**NSLPP MEETING HELD ON 13/09/23****Attachments:**

ADDRESS/WARD: Adjacent to 476 Miller Street, Cammeray**APPLICATION No:** DA104/23**PROPOSAL:** Installation and operation of a freestanding advertisement structure for the purposes of Council communication and third-party advertising**PLANS REF:**

OWNER: North Sydney Council is the registered owner of public road reserves within the North Sydney LGA**APPLICANT:** JCDecaux Australia Trading Pty Ltd**AUTHOR:** Annelize Kaalsen of AK Planning**DATE OF REPORT:** 18 July 2023**DATE LODGED:** 28 March 2023**AMENDED:** 28 August 2023**RECOMMENDATION:** Approval

Figure 4: Footpath width and pedestrian movement

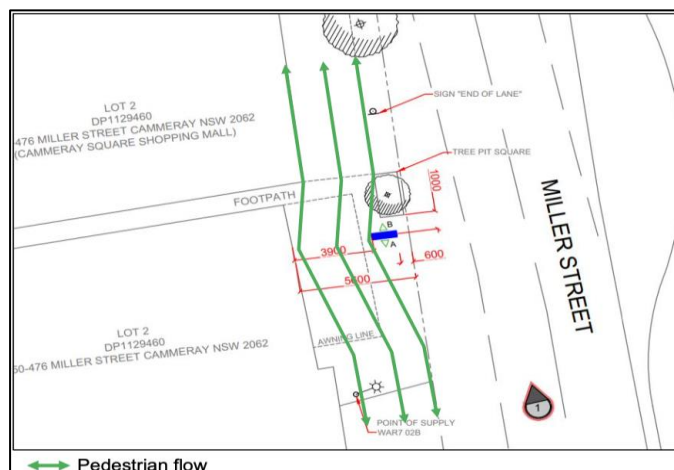
The existing footpath width is approximately 3.8m between the building and the existing street trees. The proposed panel is located at a widening of the footpath where the footpath along Miller Street widens to approximately 4.7m due to the ground level set back of the adjacent building. The proposed panel would reduce the useable footpath width to 3.9m – see **Figure 5**.

As such the remaining footpath width is in accordance with Councils control.

Figure 5: Perspective of JCDecaux logo

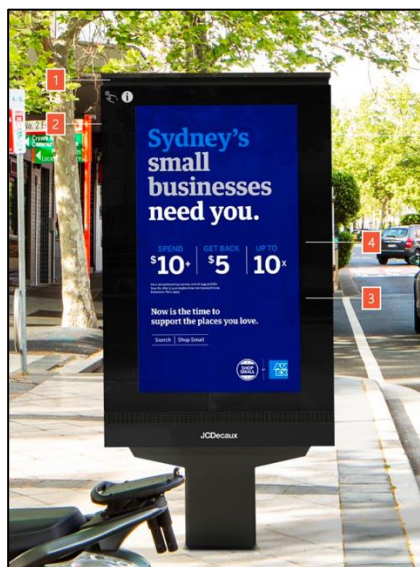
The JCDecaux logo at the bottom of the advertising panel is measured at 200mm x 40mm totalling 0.008sqm, complying with Clause 3.18 – refer to **Figure 6**.

Figure 6: Road clearance criteria
 Source: Transport corridor guide p.38

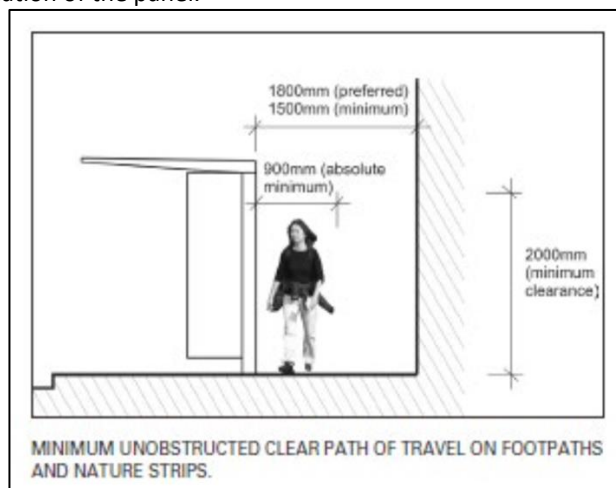
Additional road clearance criteria for footpath/nature strip signs:
 To ensure adequate clearance for pedestrian and wheel chair access, the sign must be positioned so that an absolute minimum envelope of 900mm x 1800mm x2000mm (clearance) of unobstructed clear path of travel is maintained for the entire length of the advertising structure (see figure below).

The panel is to be located on an isolated area of the footpath with a clearance of more than 2m with the existing awning stopping short of the location of the panel.
